Subject: FW: Hedwig Suites - RFI 8
Attachments: P1.01 - PLUMBING LEVEL 5 UNDERFLOOR PLAN - A.PDF; P1.02 - PLUMBING LEVEL 5 UNDERFLOOR PLAN - B.PDF

From: Theresa Chambless <tchambless@kaim-inc.com>
Sent: Thursday, January 17, 2019 11:31 AM
Subject: Hedwig Suites - RFI 8

Tenant Improvements
Memorial Plastic Surgery
Hedwig Village, TX
KAI Project No.: 3724

1 PLUMBING UNDERFLOOR PLAN - LEVEL 5 - AREA A
SCALE: 1/4" = 1'-0"

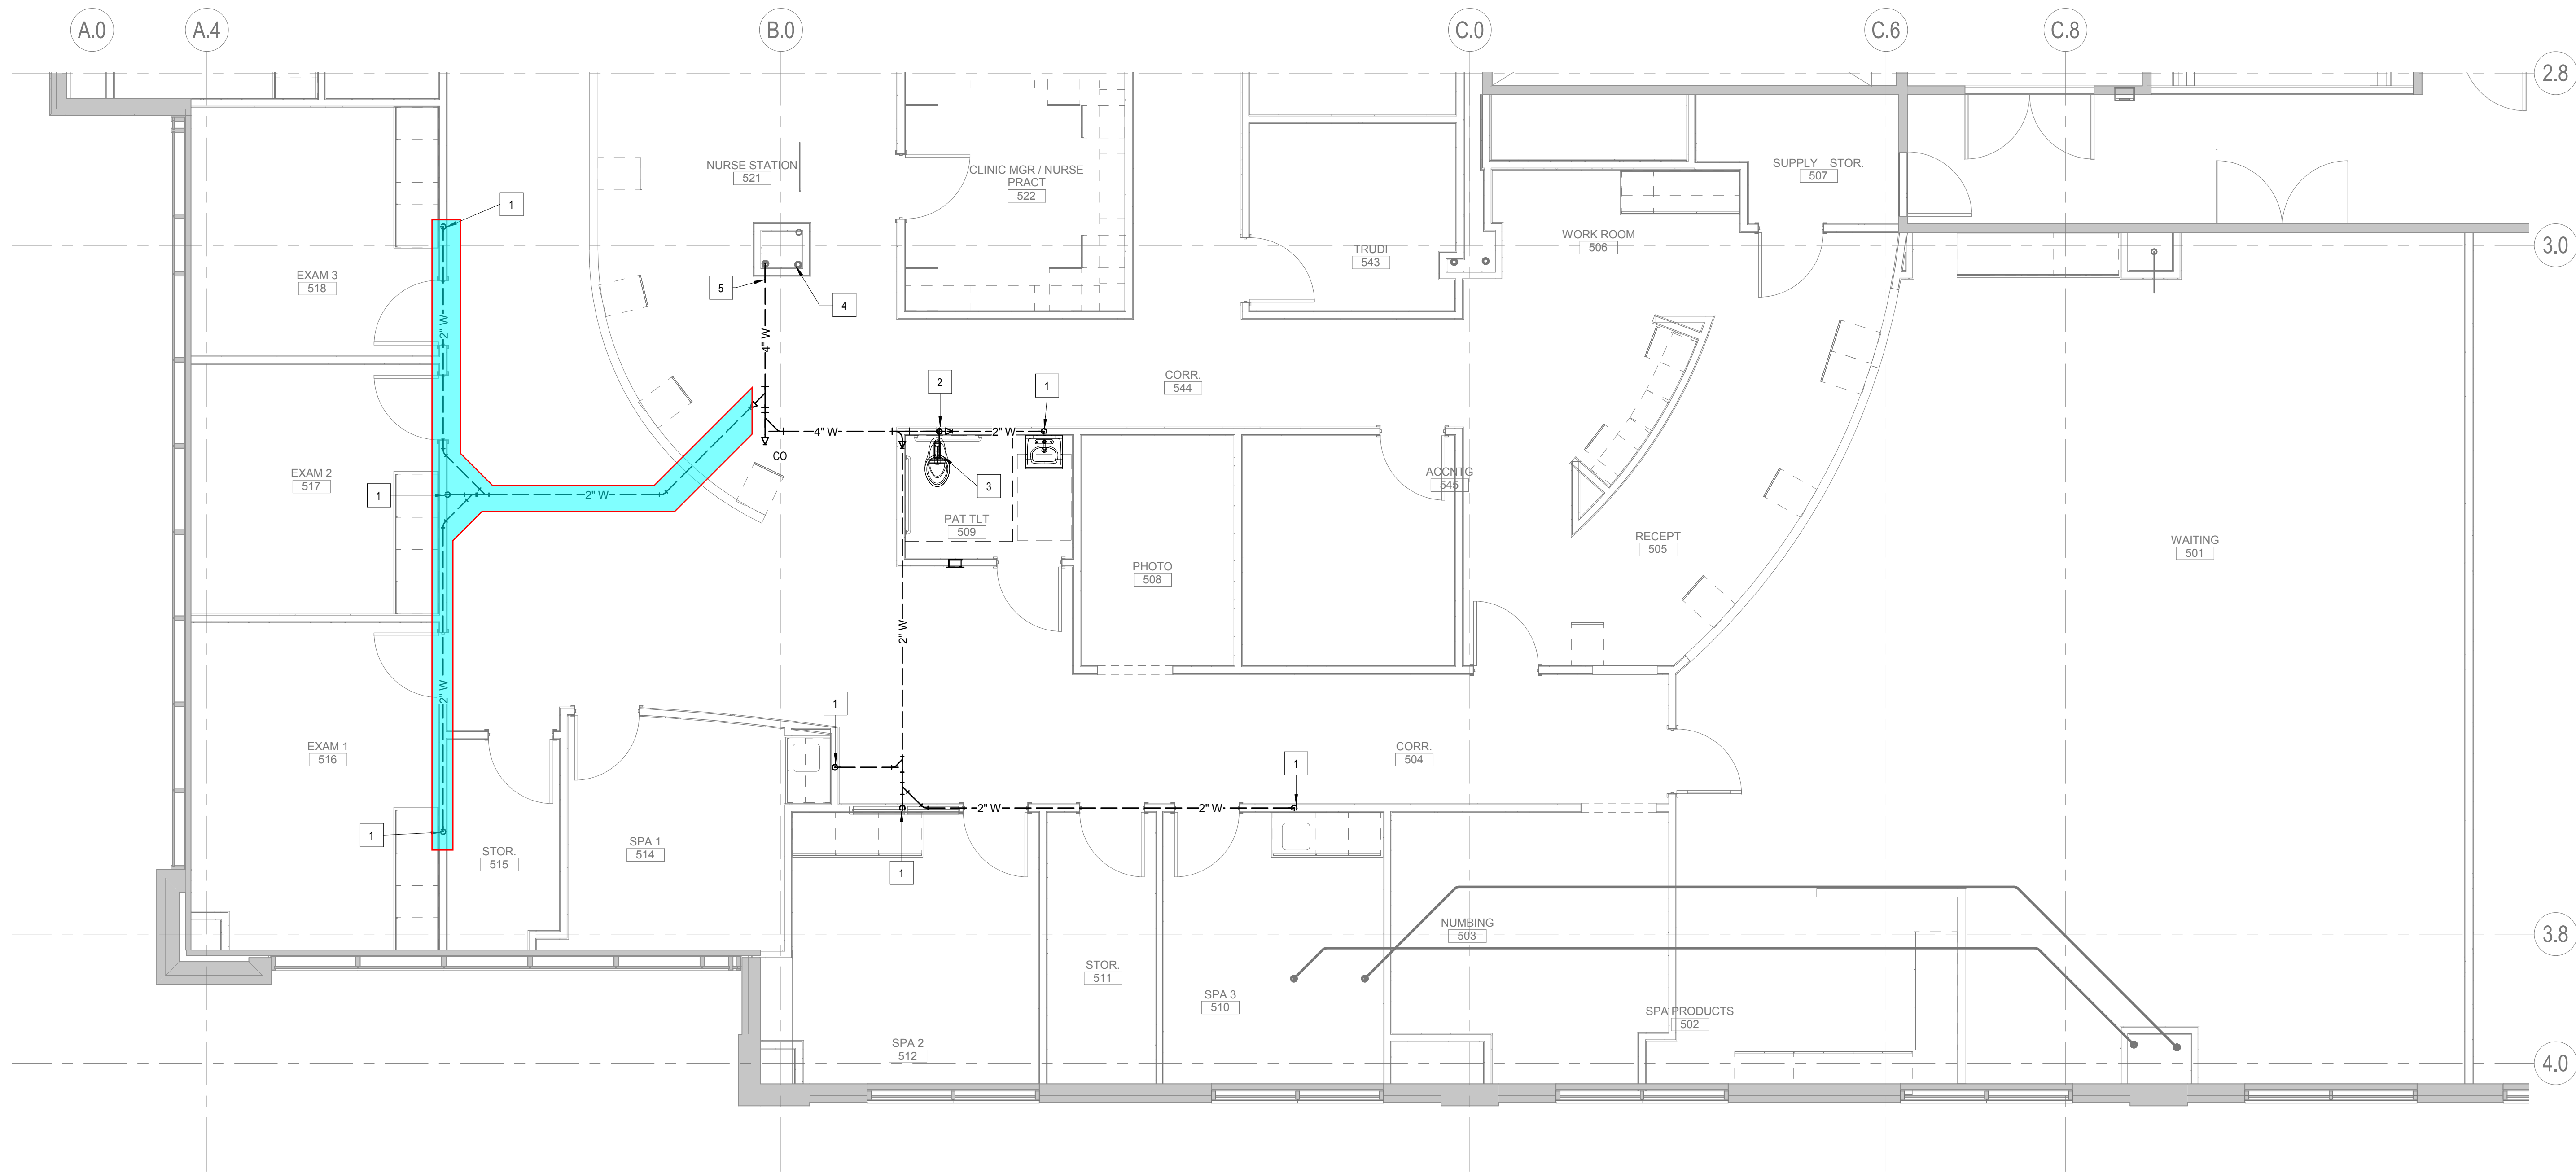
Include additional secondary containment in your bids for the highlighted areas on the attached plans. An ASI including this revisions will be issued at a later date.
